ADDENDUM NO. 01

DATE: August 25th, 2025

RE: Public Safety Training Center
SCO Project # 24-27879-01A

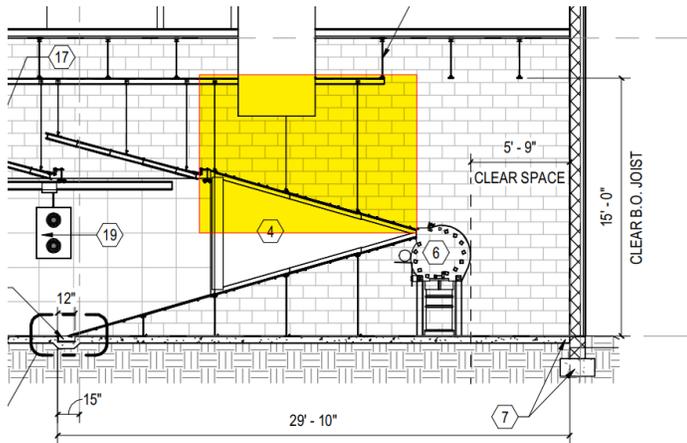
24. The lighting plan on sheet E101 shows fixtures in the range extending over the exterior wall. Based on the length of the fixtures and of the room itself, I would assume the bottom row of fixtures is not supposed to be there. Please clarify. *Response: See attached revised E-101 drawing.*

42.

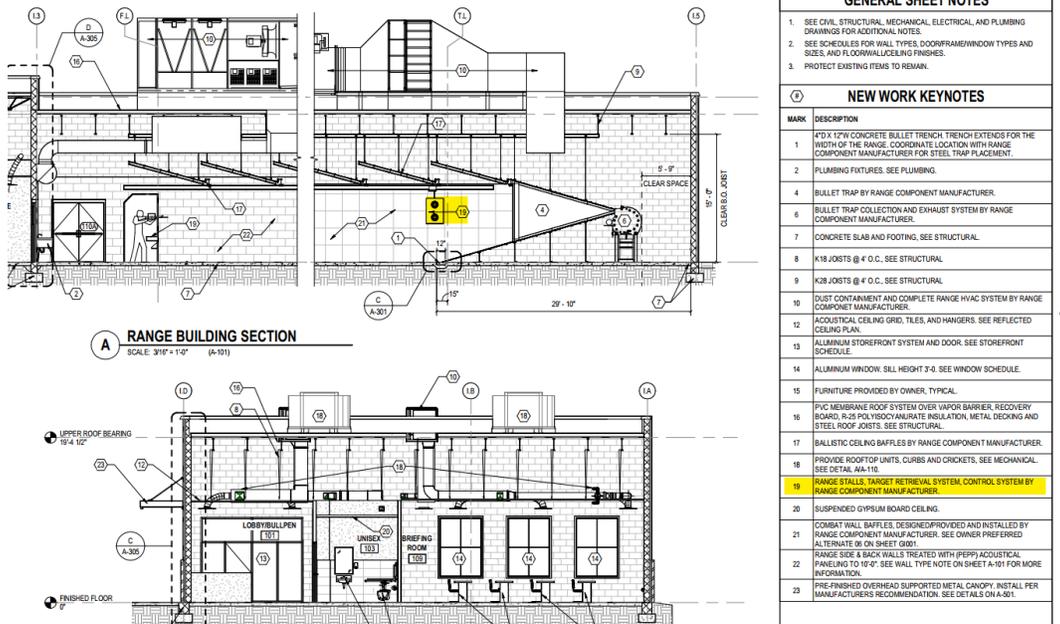
- 39. Question 1: 2.2.A.1.h: States: “Trap: Fully self-supported requiring no prior construction site preparation other than a flat concrete pad with prepared trench and an optional boom”. *Response: Understood- There will be overhead structure in this location.*
 - The trap does require an overhead structure for the funnel plates to hang from. This spec appears to have been left in by accident. Drawing page A-301 is shown correctly, see below. The funnel plates are hung from the structure overhead.

- - It’s our recommendation for 2.2.A.1.h be omitted to avoid confusion. *Response: Section 2.2.a.1.h has been removed.*
- 40.
- 2.2.A.13: is the spec for the Dust Collection System which is a required component of the steel trap. The drawings do not indicate where the unit will be located? This unit requires power and a concrete pad that would not be included by the Range Vendor. I want to make sure that other trades like electrical and concrete are planning for this item. *Response: The dust collection system is now correctly shown with a concrete pad and power.*
- 41.
- 2.3.A.1: Which ballistic rating is required for the shooting stalls? It would make sense that the stalls be rifle rated to match the bullet trap and the calibers used on the range. *Response: The shooting stalls are to be rifle rated similar to bullet trap.*

43.

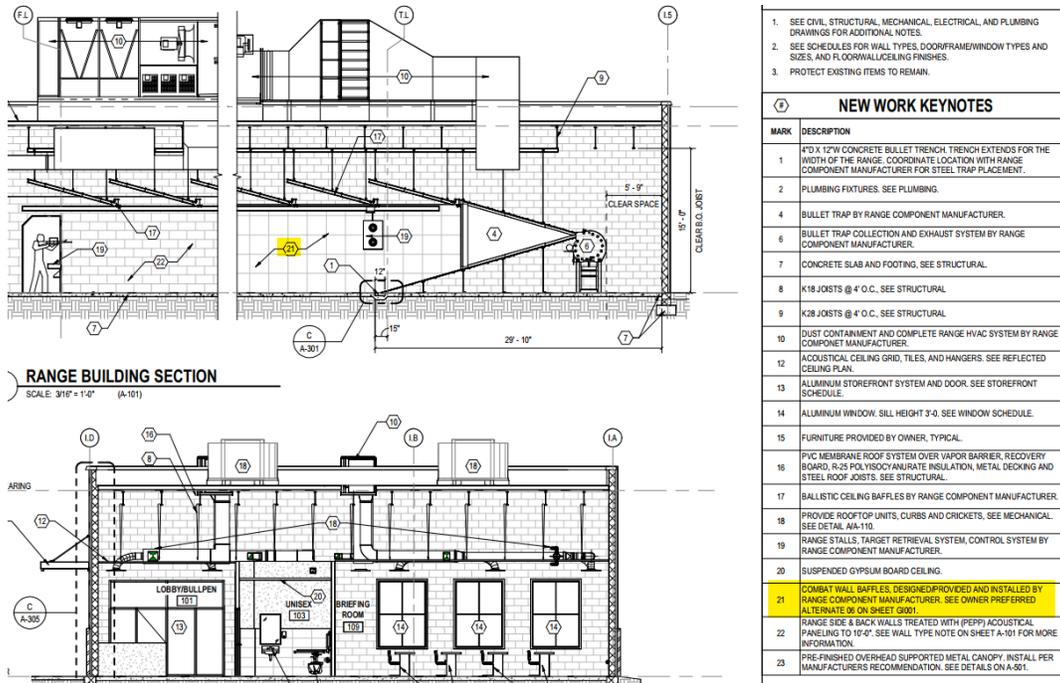
- 2.4 is a specification for a fixed turning target. The drawings, see below on page A-301, show a target retriever and previous budgets included a Target retriever. Is a different type of target the intent of the bid? If not, can the spec section be updated to the correct equipment type? **Response: The system will be a target retrieval system. The spec has been updated.**

WALL SECTION AT RANGE -
WALL BAFFLES
SCALE: 3/4" = 1'-0" (A-305)

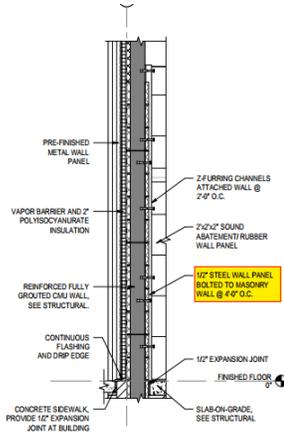
- 2.6.B is the Wall Baffle Spec. What height should the steel be from AFF? What length up range should the Wall Baffle extend to? What is the height of the rubber panels from AFF?
 - Here is page A-301 from the drawings: **Response: See updated architectural drawings for more dimensions on Wall Baffle system.**

- 2.6.B.5 requires the steel of the Wall Baffle to be 3/8" AR500 steel which is standard. Detail B on drawing page A-305 shows the steel as 1/2" which is not a standard option and would increase the cost of the project unnecessarily. Please provide clarity on which is required. *Response: The steel shall be 3/8" per specifications. See updated architectural details as well.*

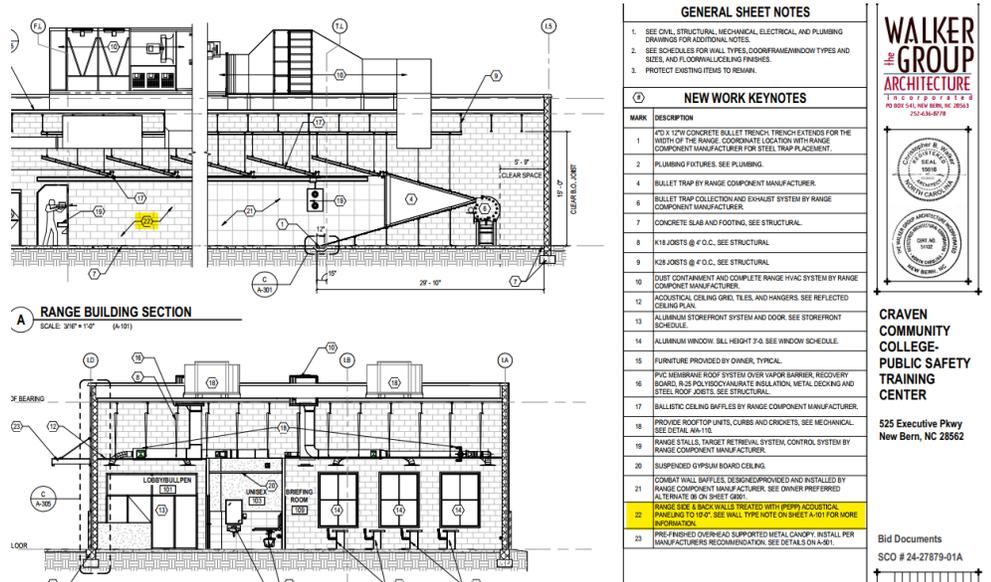
- There doesn't appear to be a spec section for any additional sound abatement on the side walls. The drawings list PEPP as the sound abatement details are in the following locations: *Response: A specification has been added for the sound abatement.*

- Wall Type Note 3 on page A-101:

46.

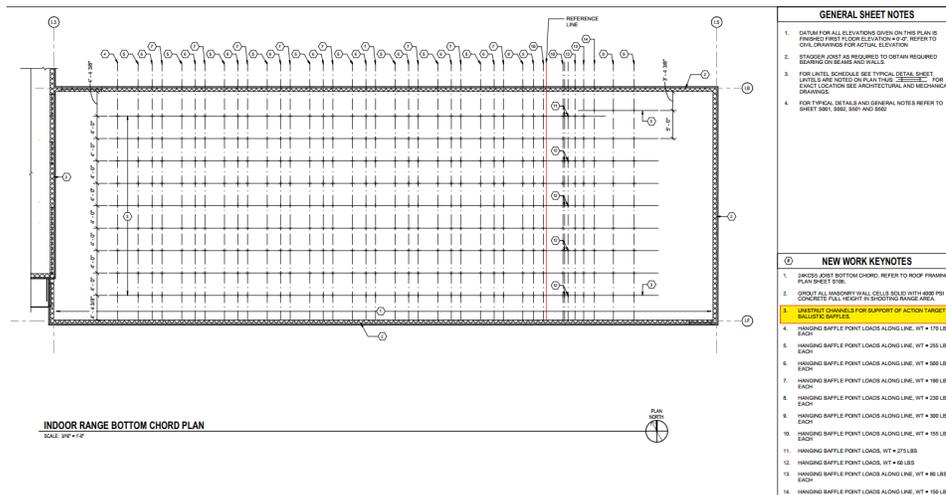
- Note 22 on page A-301.

i. Drawing page E-201:

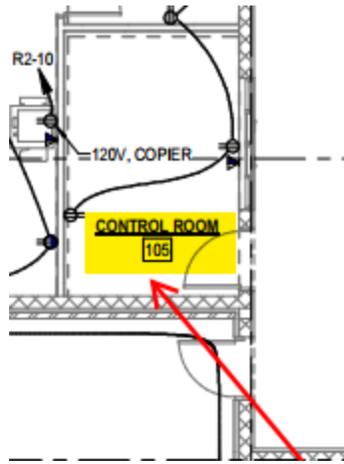
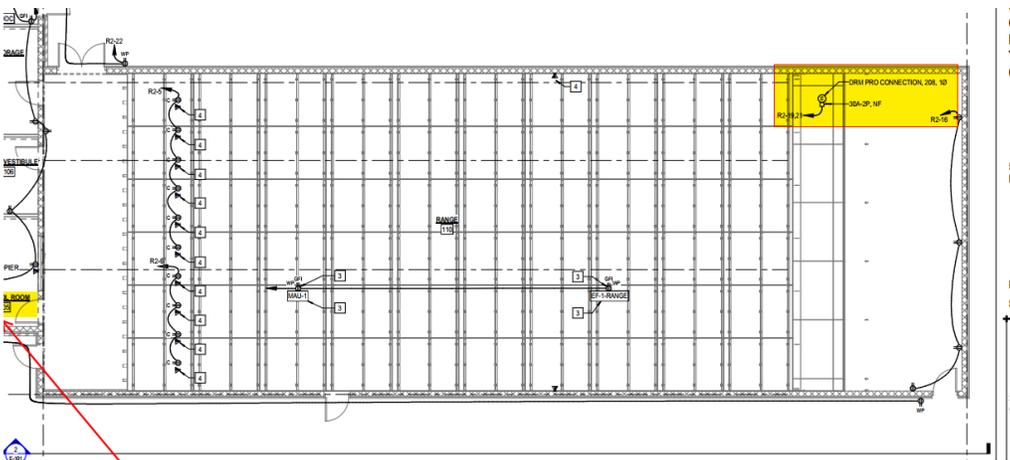
48. A server and master control screen will be mounted in the Control Room, room 105. Where will the server be located in the control room? A standard 120v plug will be needed as well. Has that been accounted for? *Response: Receptacles have been provided accordingly.*

- a. Drawing page E-201 shows an electrical requirement for a DRM Pro. The specification section 11 67 23 does not call for a DRM Pro and the range section view on page A-301 doesn't show a DRM Pro. Is a DRM Pro required? If yes, can the specification be added? *Response: A specification has been added for the Running Man Target System and it is now shown on reflected ceiling plan.*
